ADDENDUM NO. 5

REGIONAL PARK RESTROOMS
PROJECT NUMBER 122013

The following revisions to the Plans shall be made:

1 ENLARGED TOPOGRAPHIC SURVEY, DEMOLITION AND CONSTRUCTION PLAN
SCALE: 1" = 10'

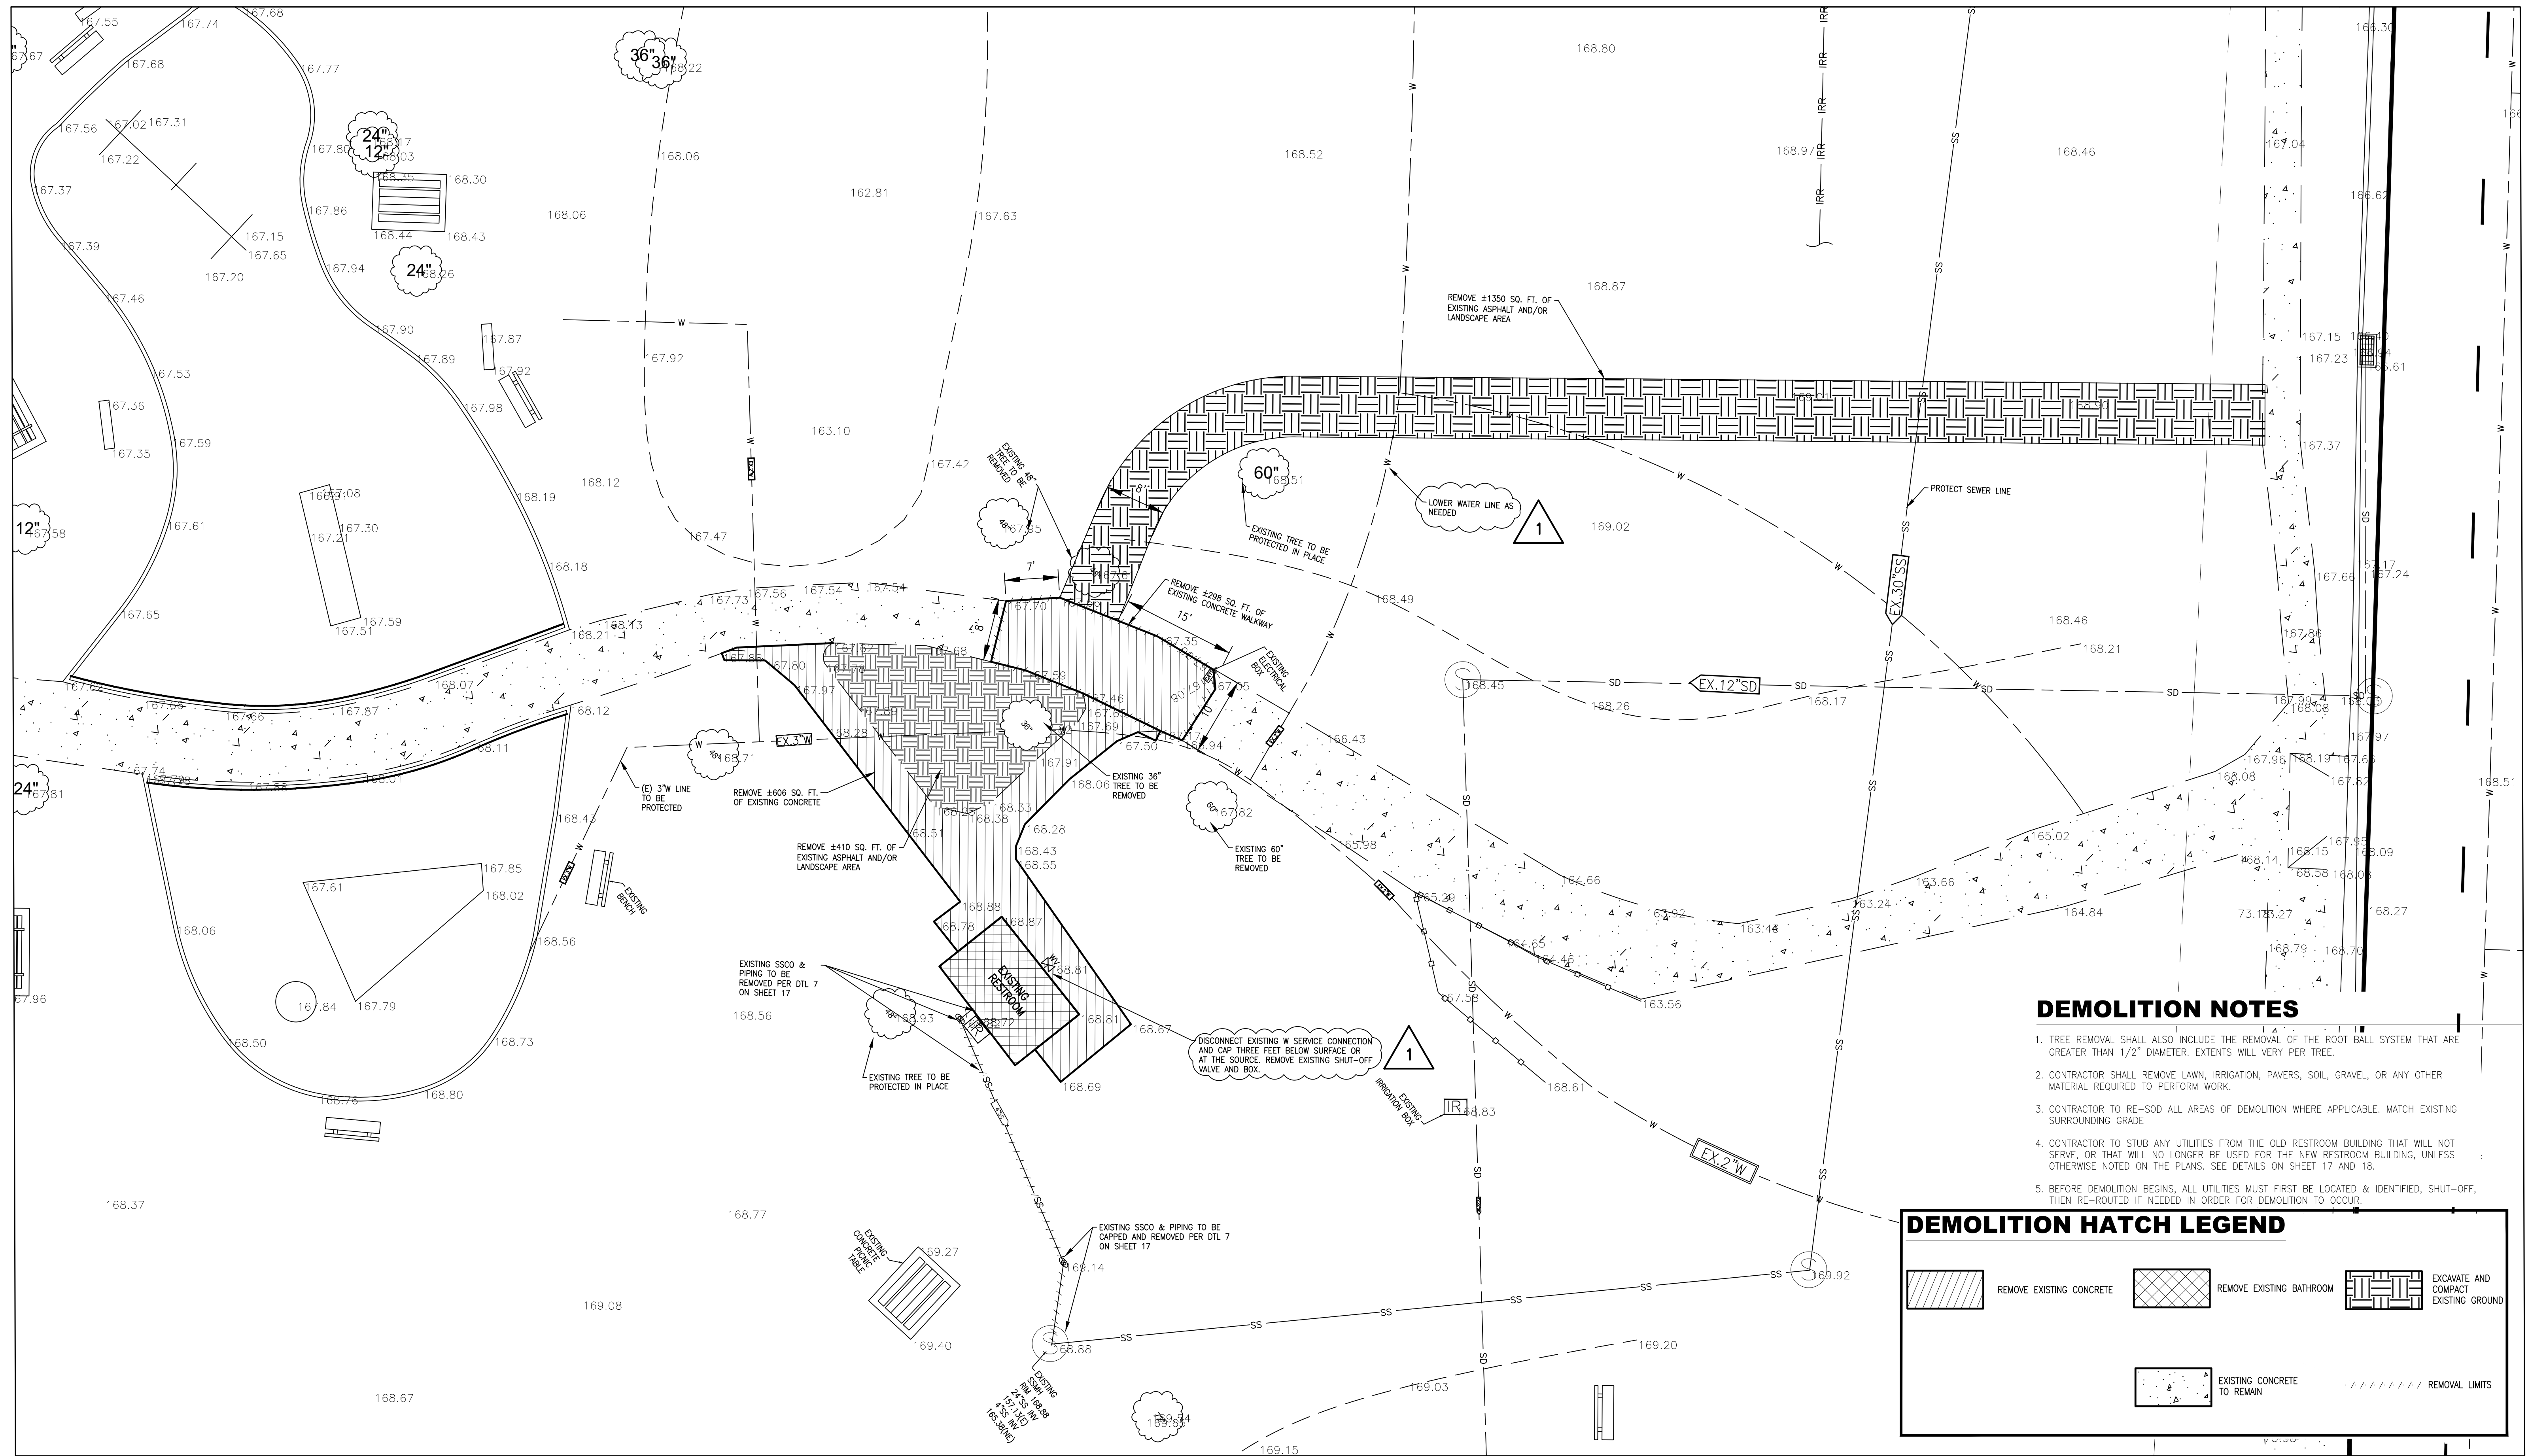
NO.	DATE	BY	REVISION MADE
1	2/22/2023	VM	Protect and lower water line as necessary when installing walkway
2	2/22/2023	VM	Added cap 3' below surface to water disconnection

1 ENLARGED TOPOGRAPHIC SURVEY, DEMOLITION AND CONSTRUCTION PLAN

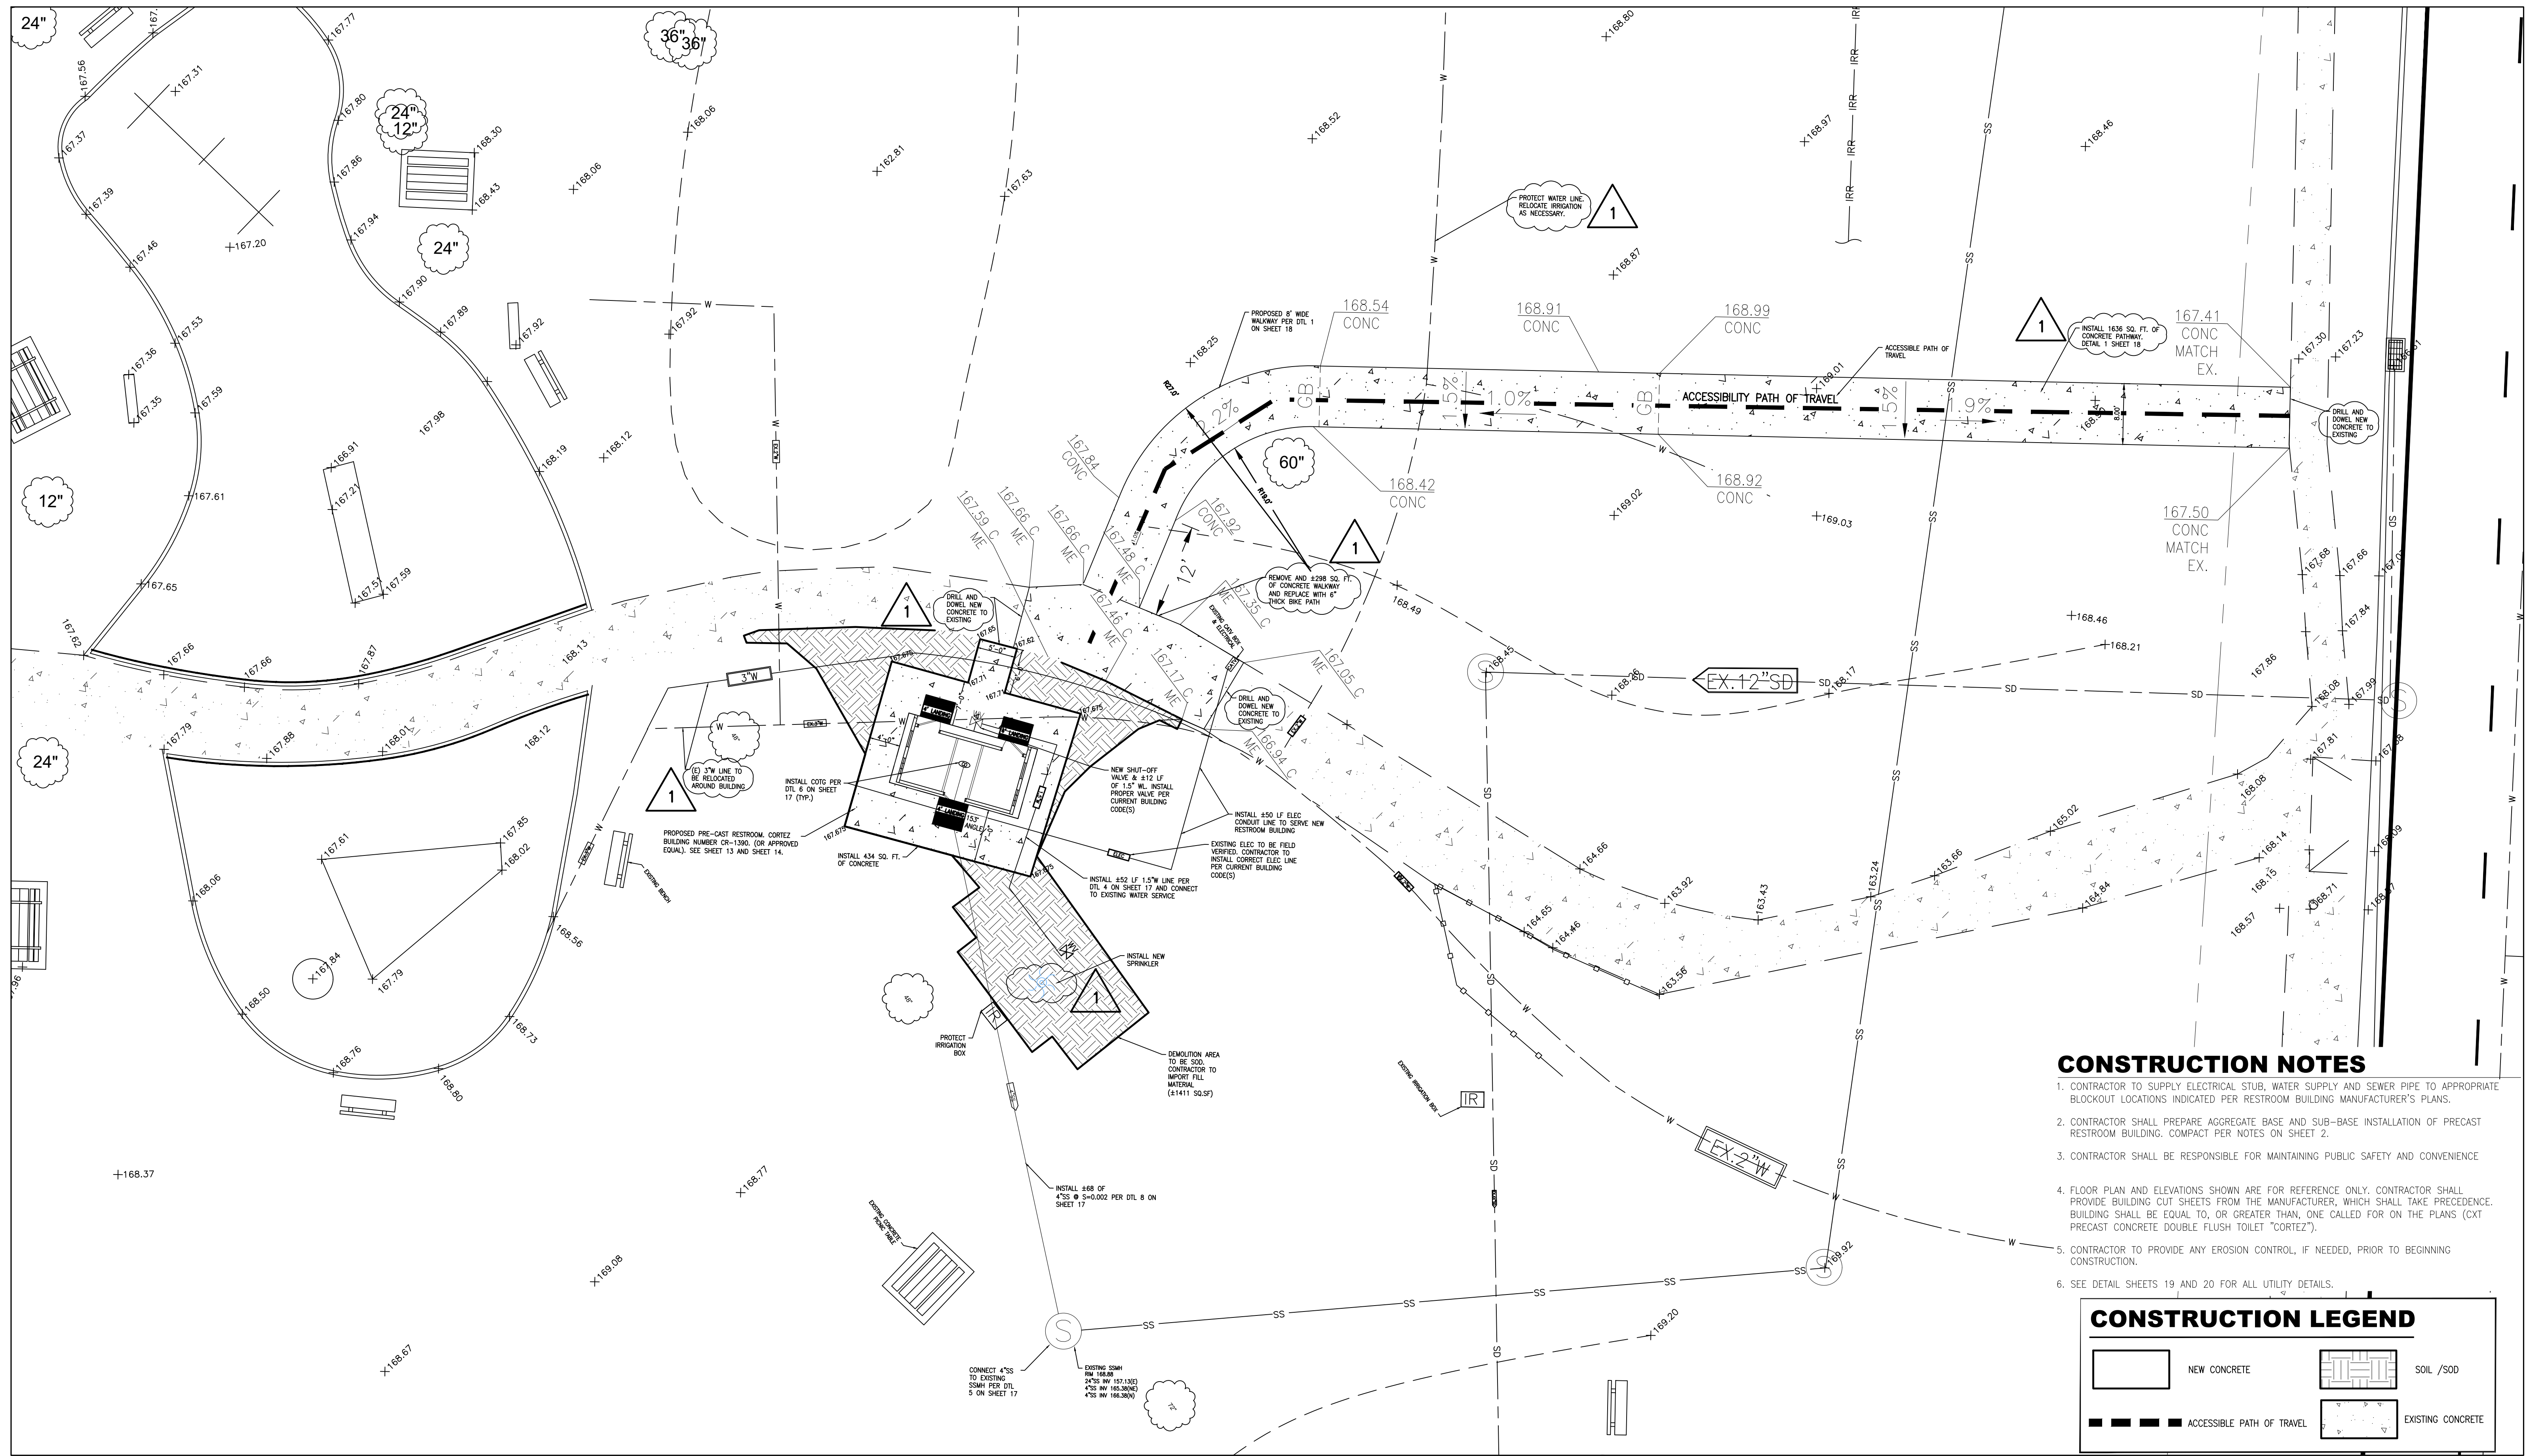
NO.	DATE	BY	REVISION MADE
1	2/22/2023	VM	Relocate 3" water line outside building footprint
2	2/22/2023	VM	Drill and dowel new concrete into existing concrete
3	2/22/2023	VM	Added detail 1 sheet 18 to concrete walkway note
4	2/22/2023	VM	Install new sprinkler where old restroom was demolished
5	2/22/2023	VM	Bike path to be 6" thick concrete
6	2/22/2023	VM	Relocate IR as necessary
